ADDENDUM #3

CITY HALL HVAC UPGRADE

BID #14/15-008 – PWP# WA-2015-012

**SPARKS CITY HALL
 CAMPUS HVAC UPGRADE
 SPARKS, NEVADA**

A
E0.2
 EXISTING SINGLE LINE DIAGRAM
 SCALE: NTS

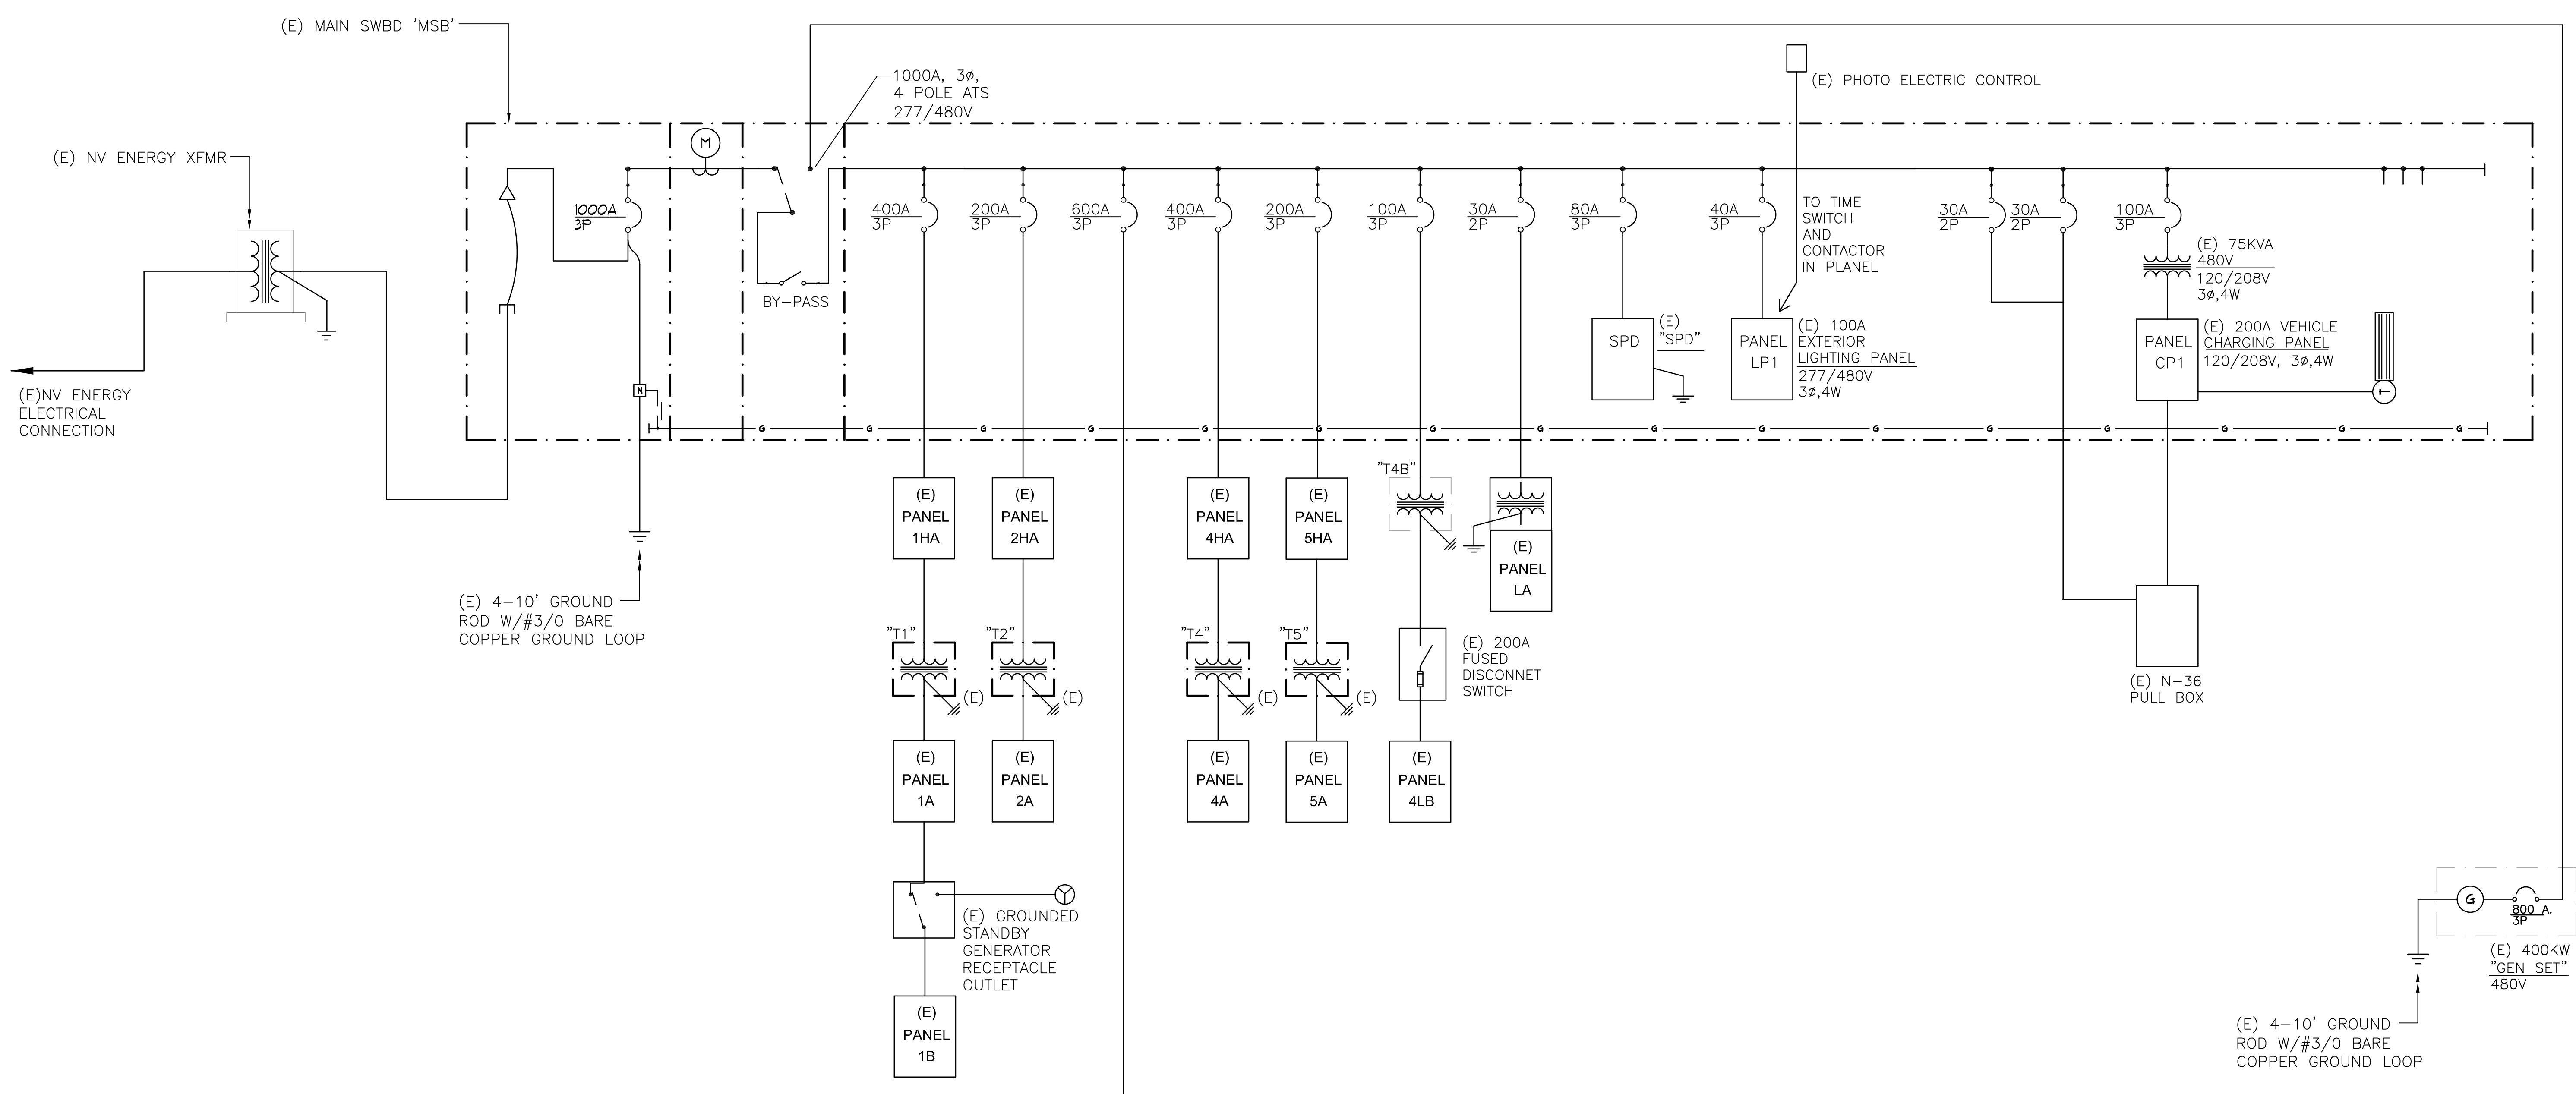
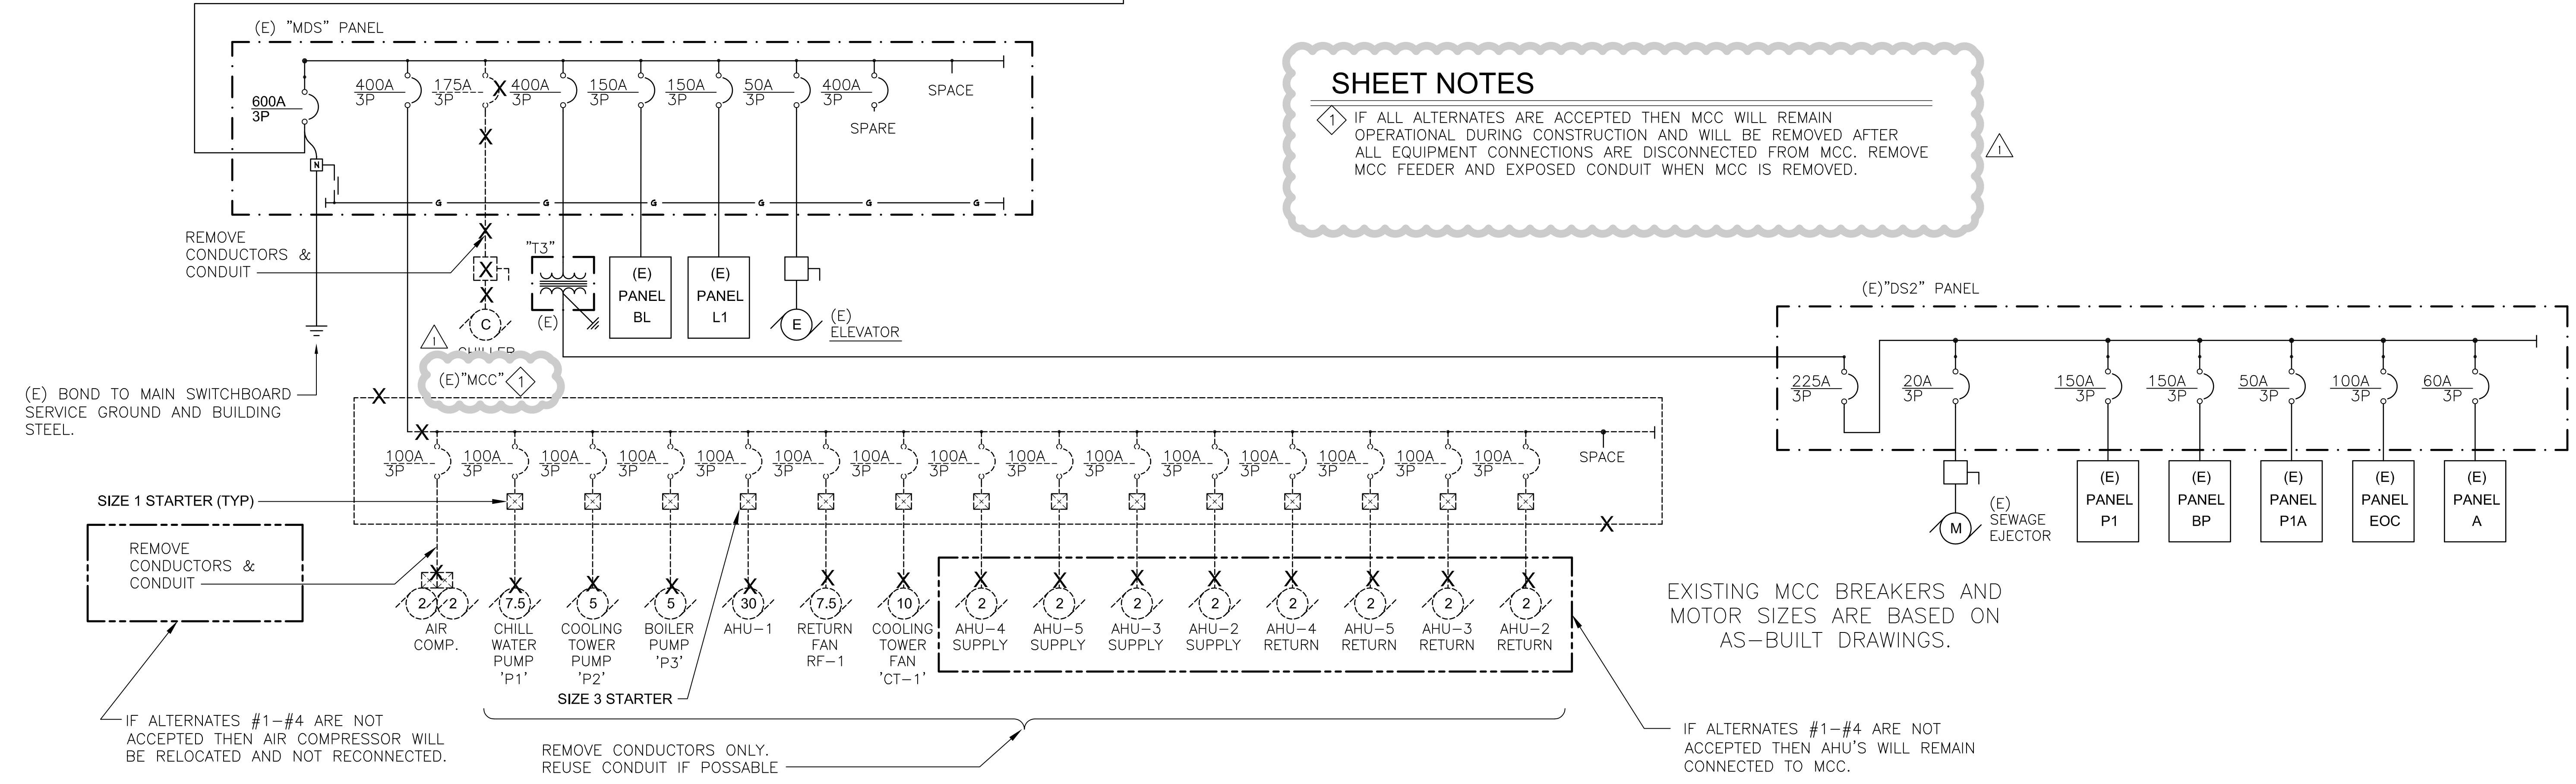
SHEET NOTES
 ▲ IF ALL ALTERNATES ARE ACCEPTED THEN MCC WILL REMAIN OPERATIONAL DURING CONSTRUCTION AND WILL BE REMOVED AFTER ALL EQUIPMENT CONNECTIONS ARE DISCONNECTED FROM MCC. REMOVE MCC FEEDER AND EXPOSED CONDUIT WHEN MCC IS REMOVED.

A
E0.3
 NEW SINGLE LINE DIAGRAM
 SCALE: NTS

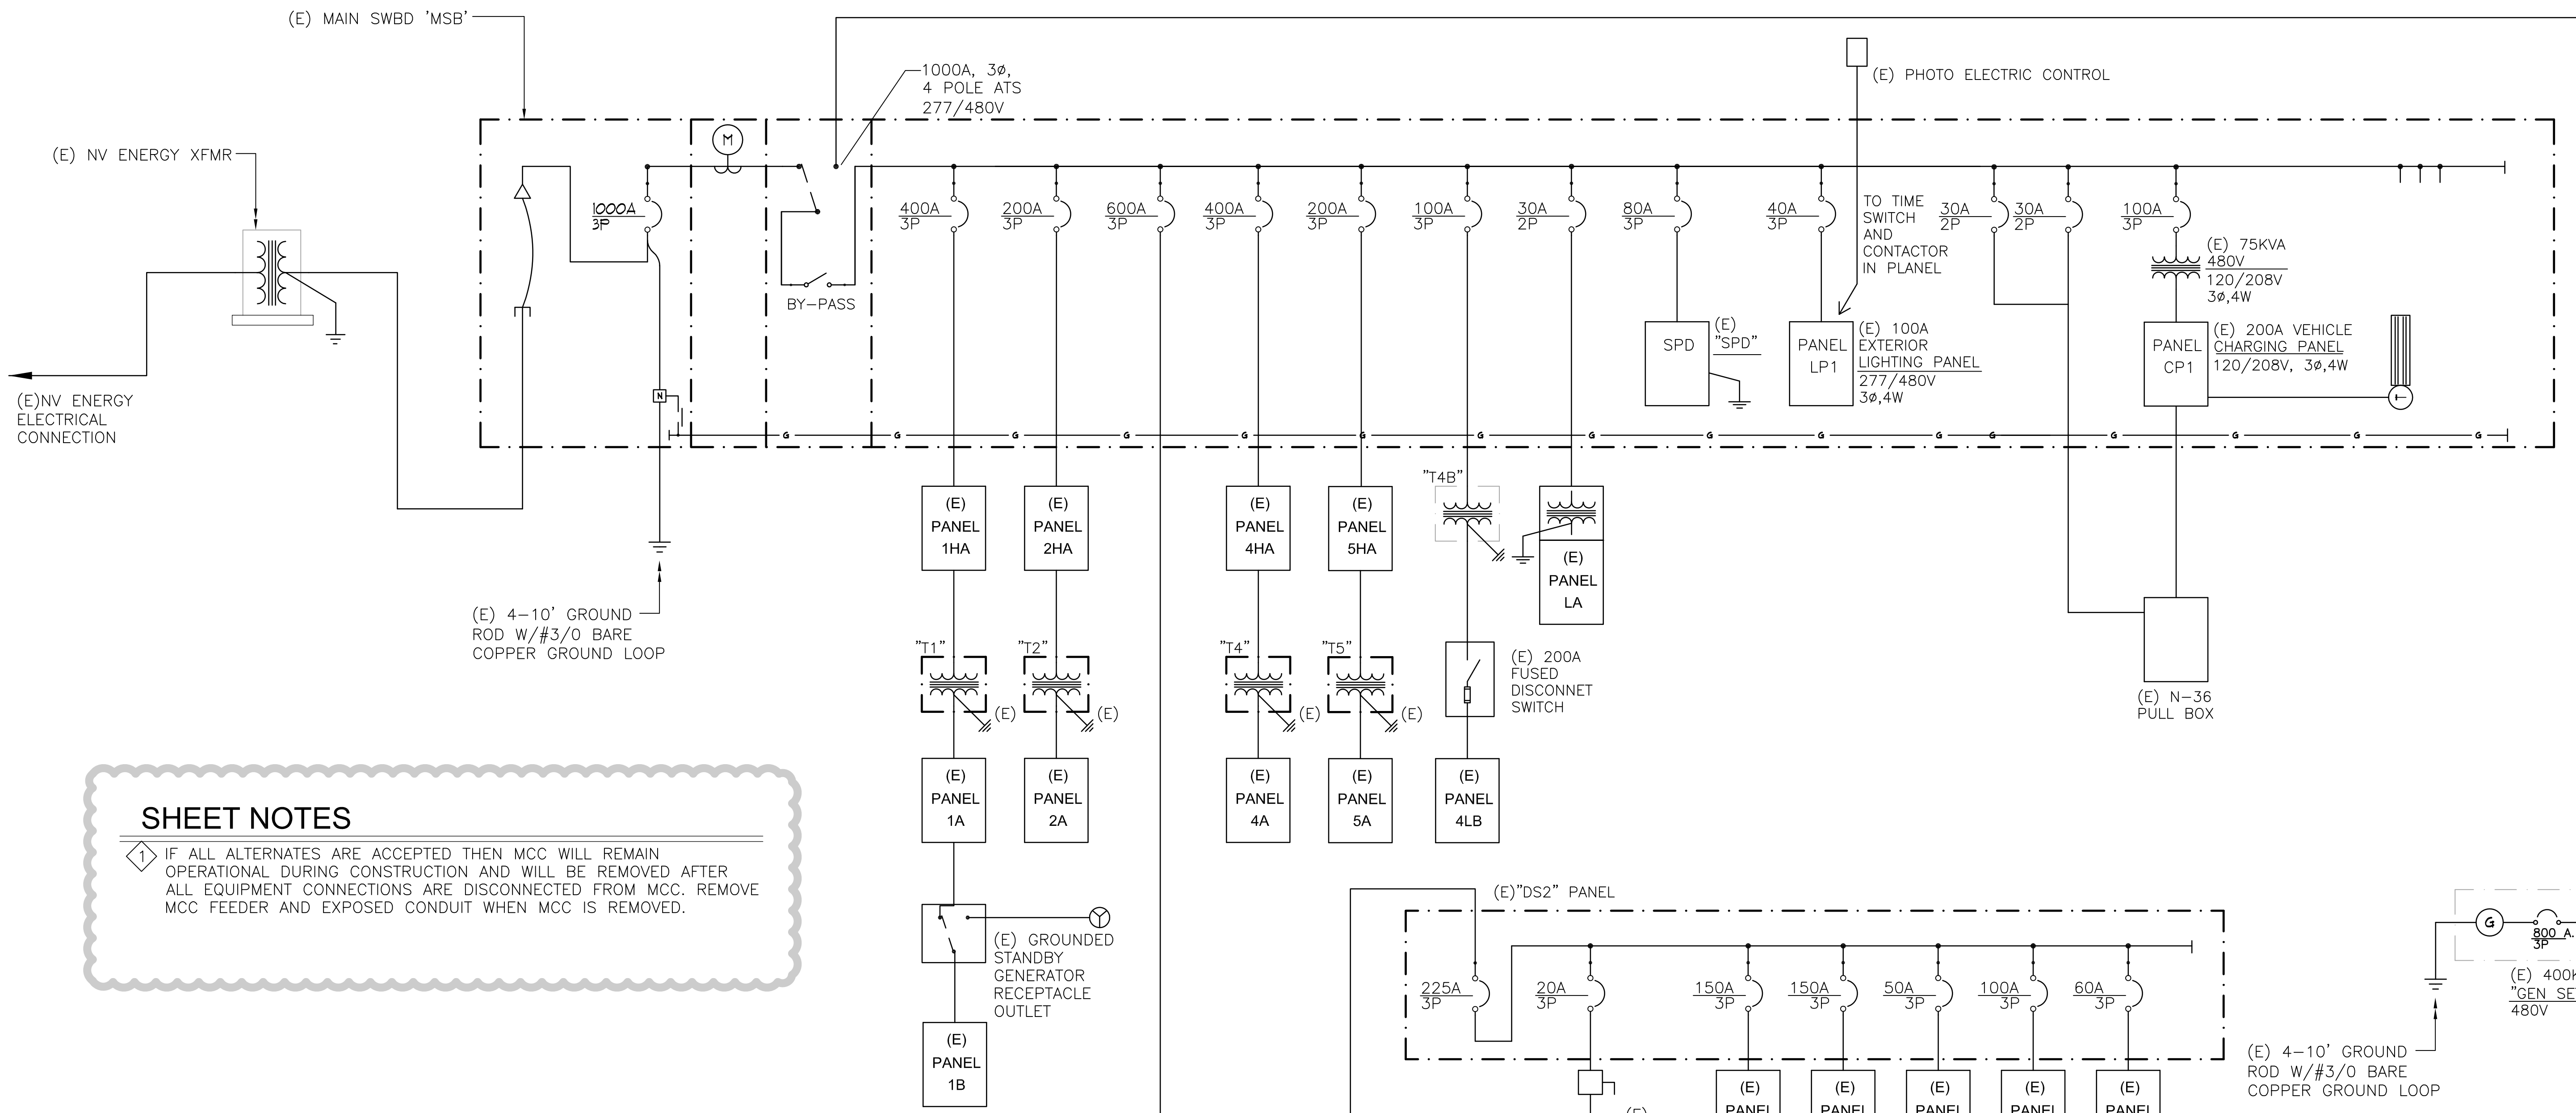
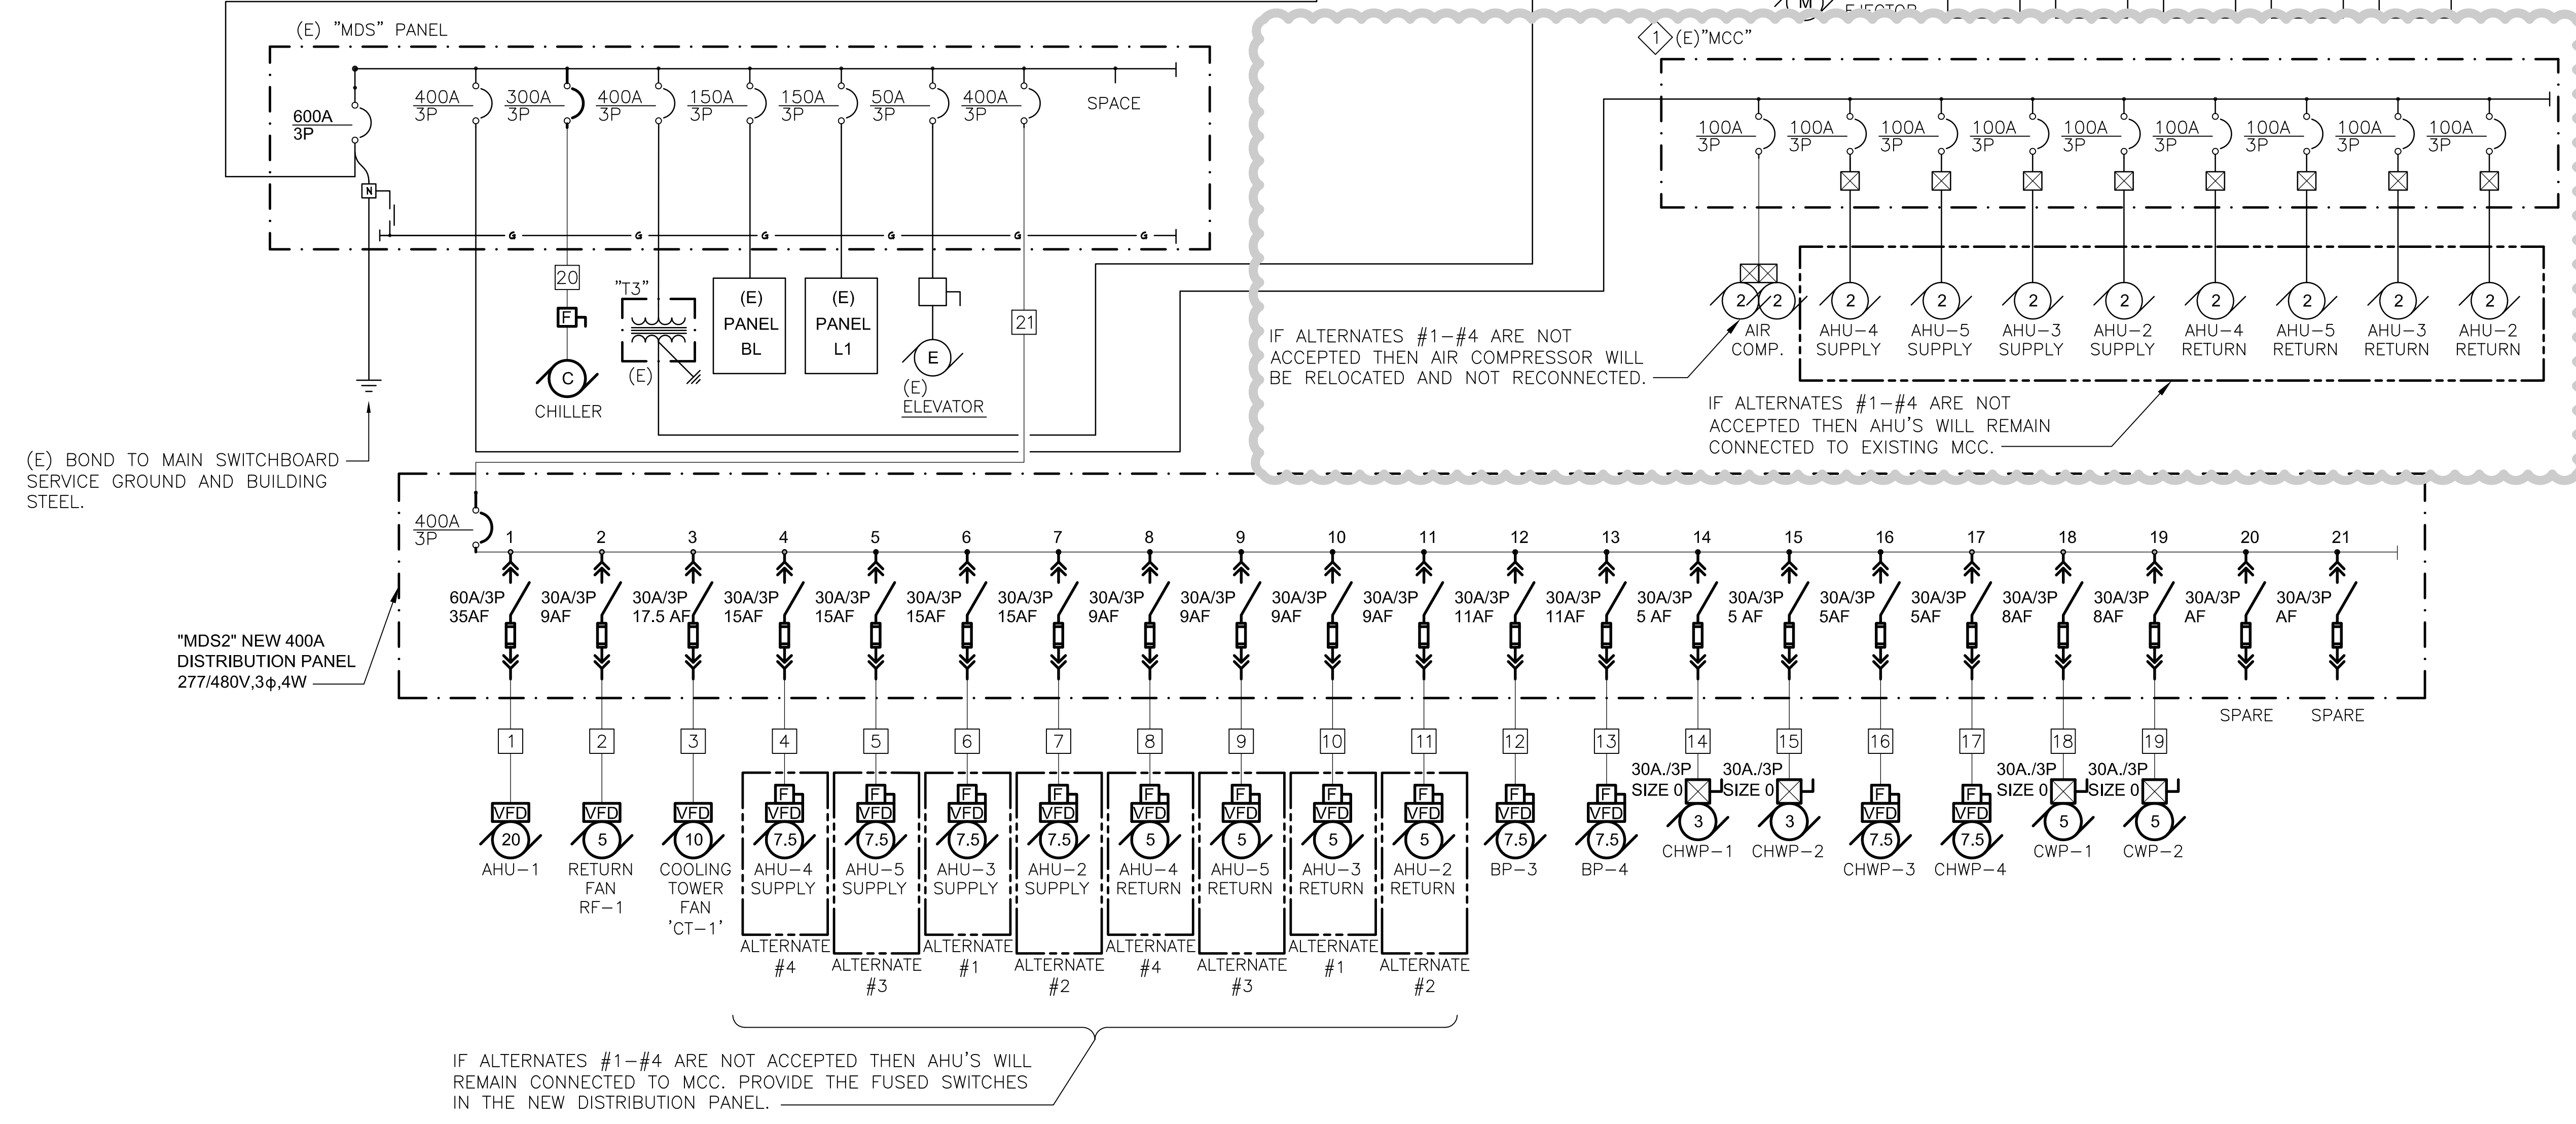
SHEET NOTES
 IF ALL ALTERNATES ARE ACCEPTED THEN MCC WILL REMAIN OPERATIONAL DURING CONSTRUCTION AND WILL BE REMOVED AFTER ALL EQUIPMENT CONNECTIONS ARE DISCONNECTED FROM MCC. REMOVE MCC FEEDER AND EXPOSED CONDUIT WHEN MCC IS REMOVED.

IF ALTERNATES #1-#4 ARE NOT ACCEPTED THEN AHU'S WILL REMAIN CONNECTED TO MCC. PROVIDE THE FUSED SWITCHES IN THE NEW DISTRIBUTION PANEL.

IF ALTERNATES #1-#4 ARE NOT ACCEPTED THEN AIR COMPRESSOR WILL BE RELOCATED AND NOT RECONNECTED.
